# HISTORIC AND DESIGN REVIEW COMMISSION

June 16, 2021

**HDRC CASE NO:** 2021-100  
**ADDRESS:** 415 MISSION ST  
**LEGAL DESCRIPTION:** NCB 946 BLK 2 LOT 22  
**ZONING:** RM-4,H  
**CITY COUNCIL DIST.:** 1  
**DISTRICT:** King William Historic District  
**APPLICANT:** Jake Jazdzewski/JAZDZEWSKI JAKE & MONICA  
**OWNER:** Jake Jazdzewski/JAZDZEWSKI JAKE & MONICA  
**TYPE OF WORK:** Relocation of garage structure, modifications  
**APPLICATION RECEIVED:** May 18, 2021  
**60-DAY REVIEW:** Not applicable due to City Council Emergency Orders  
**CASE MANAGER:** Stephanie Phillips  
**REQUEST:**

# JAZDZEWSKI RESIDENCE RESIDENTIAL REMODEL

**6 RIGHT ELEVATION - NEW IMPROVEMENTS**  
SCALE: 1/4" = 1'-0"

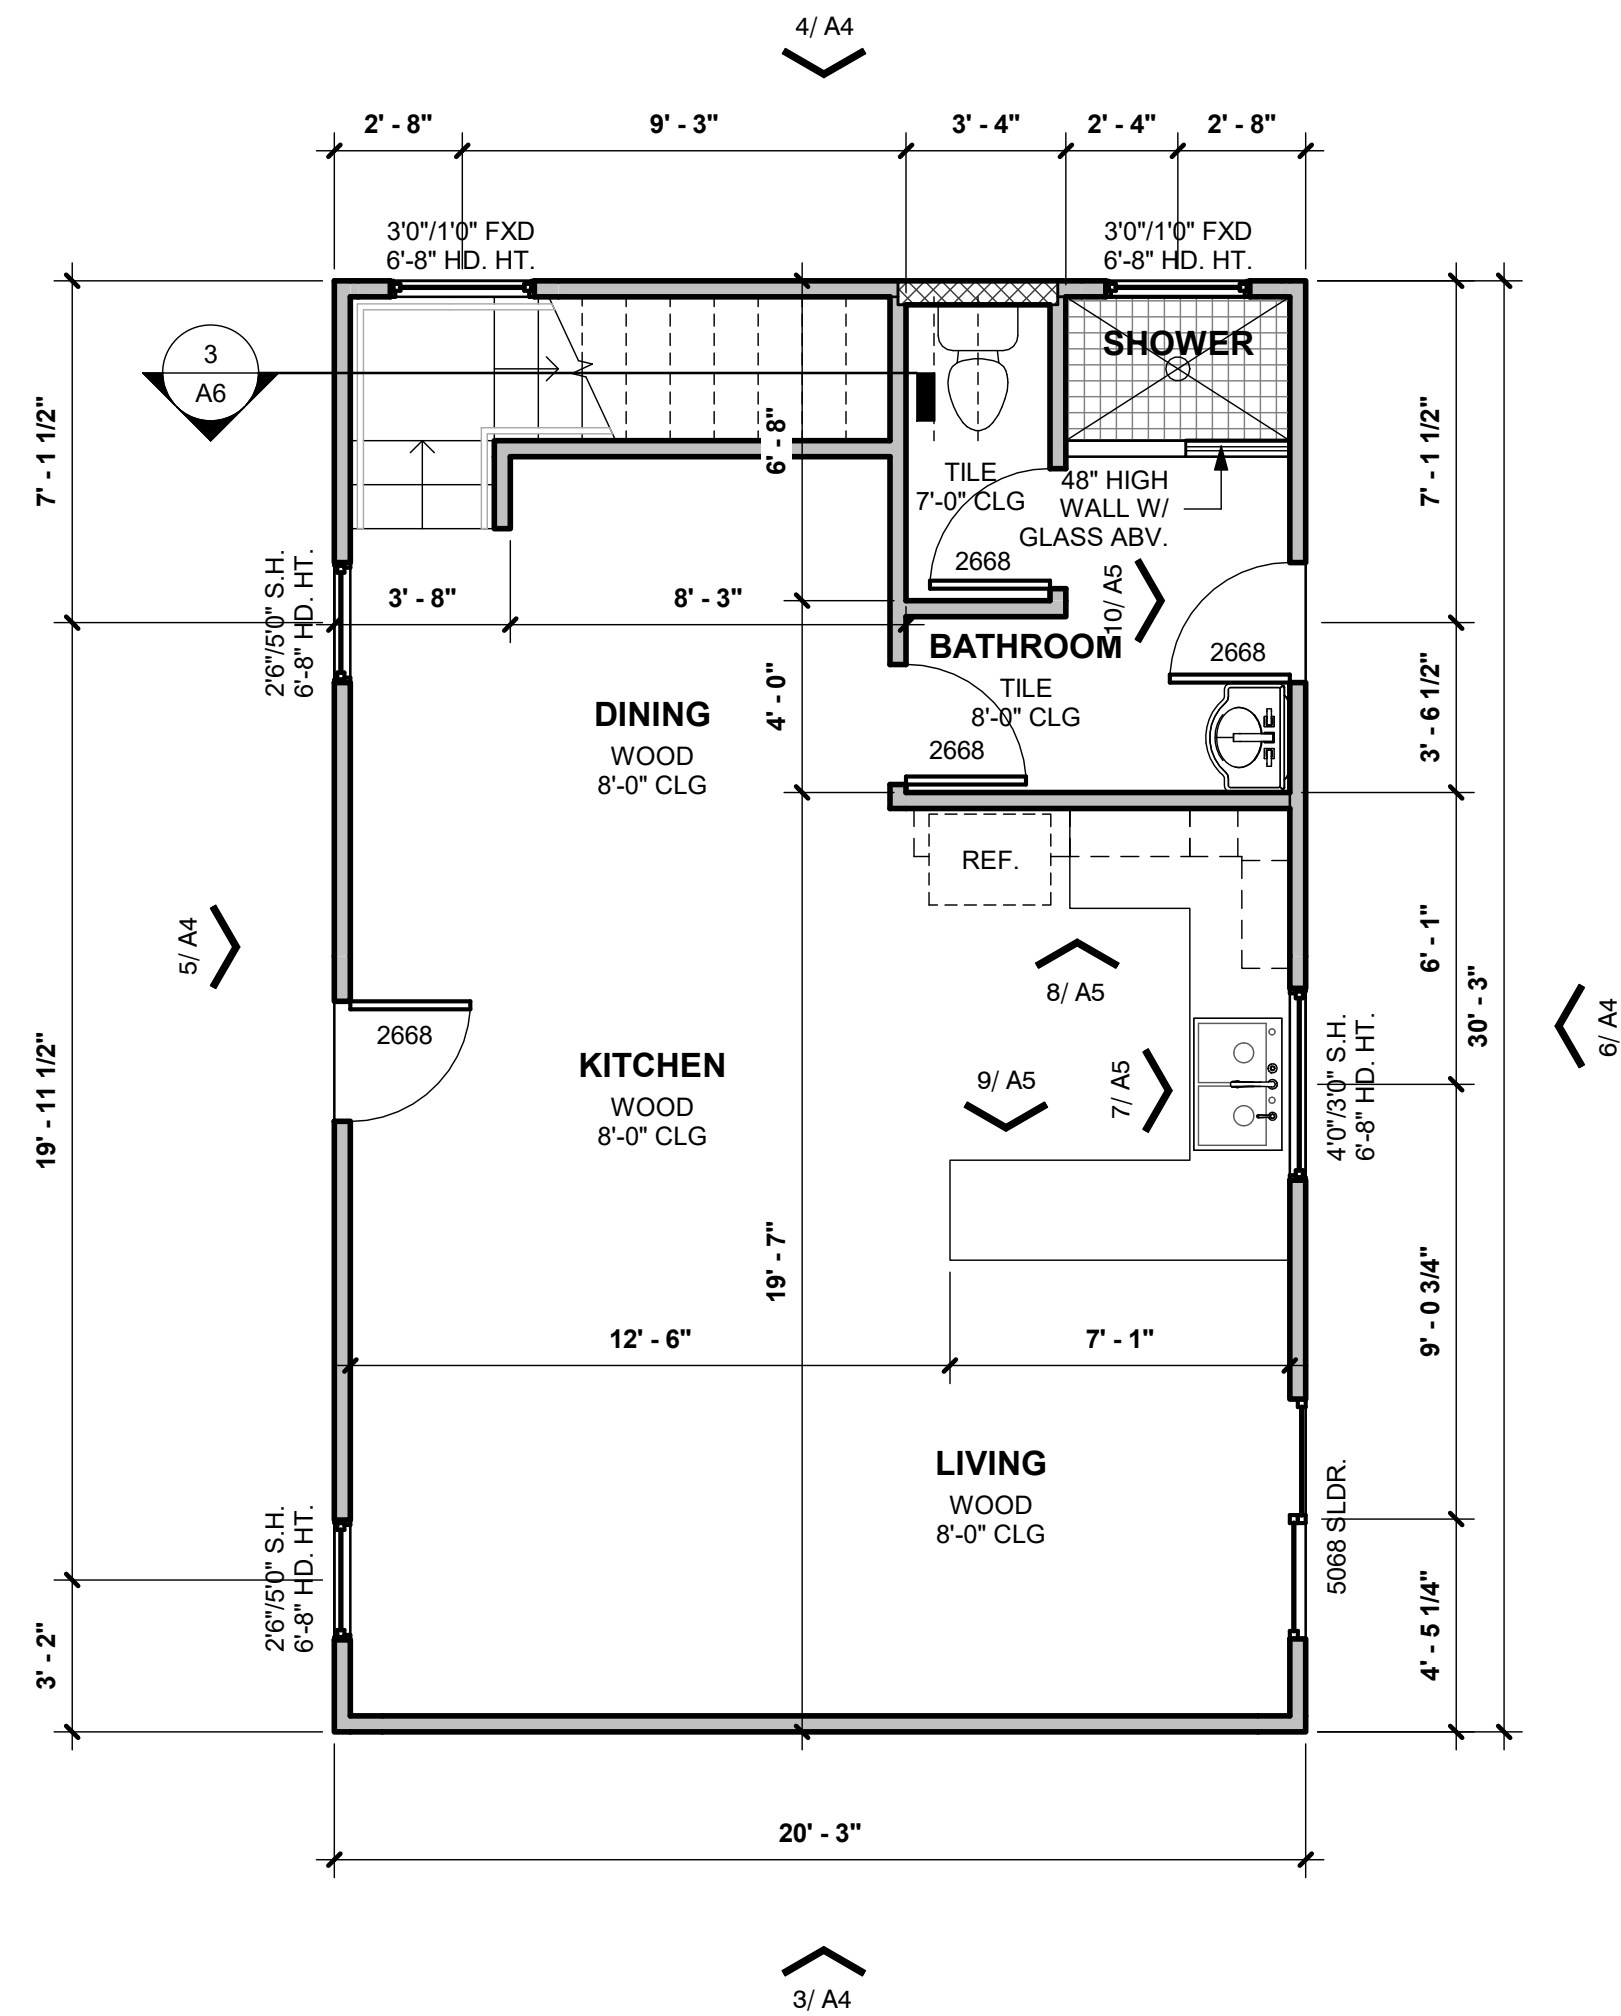
- e. FENESTRATION MODIFICATIONS – The applicant has proposed to replace an existing second story door at the stair landing with a new window to match existing in terms of scale, proportion, configuration, and inset. The awning above the door will also be removed. Staff generally finds the request appropriate, but finds that the door should be retained and reused elsewhere on the structure, or stored on the property. Additionally, the applicant has proposed to remove an existing first floor window and enclose with siding on the back elevation. An existing second story window on this elevation will be retained. Staff generally finds the request acceptable based on its limited visibility from the public right-of-way and the retention of an additional opening, but finds that the window should be retained and reused elsewhere on the structure, or stored on the property. Staff also finds the addition of new sliding doors on an ancillary elevation to be appropriate.

- f. GARAGE BAY ENCLOSURE – The applicant has proposed to enclose the open garage bay with siding to create interior space. The garage is the single story mass of the rear accessory structure and faces the primary structure. The garage does not serve a driveway, rear alley, or other parking access or configuration and is located to the west of the driveway in the rear yard. Staff finds the enclosure of the garage bay acceptable due to its limited visibility from the public right-of-way and the fact that the remaining elements of the structure, including all walls, the front half circle window, and the vertical trim pieces, will be retained, rendering the intervention reversible.

- j. **WINDOW REPLACEMENT** – The applicant has proposed to replace all existing windows with new aluminum clad wood windows per the submittal documents. According to the Historic Design Guidelines, wood windows should be repaired in place and restored whenever possible, unless there is substantial evidence that the windows are deteriorated beyond repair. If a window assembly is deemed irreparable, the window should be replaced in-kind in terms of materiality, configuration, inset, proportion, style, and detailing. As noted in finding g, staff finds that the windows are in repairable condition, with a majority of them being covered and protected over the past few decades by exterior screens. Staff does not find replacement consistent with the Guidelines.

- i. That the applicant restores all wood windows in the openings that are not proposed to be modified as noted in findings g through j. The applicant is required to submit updated drawings that reflect the window retention to staff prior to the issuance of a Certificate of Appropriateness.

- ii. That all new windows to be installed in new openings or where non-original windows exist meet the following stipulations: the windows should be wood or fully wood and feature an inset of two (2) inches within facades and should feature profiles that are found historically within the immediate vicinity. Meeting rails must be no taller than 1.25" and stiles no wider than 2.25". White manufacturer's color is not allowed, and color selection must be presented to staff. There should be a minimum of two inches in depth between the front face of the window trim and the front face of the top window sash. This must be accomplished by recessing the window sufficiently within the opening or with the installation of additional window trim to add thickness. Window trim must feature traditional dimensions and architecturally appropriate sill detail. Window track components must be painted to match the window trim or concealed by a wood window screen set within the opening.
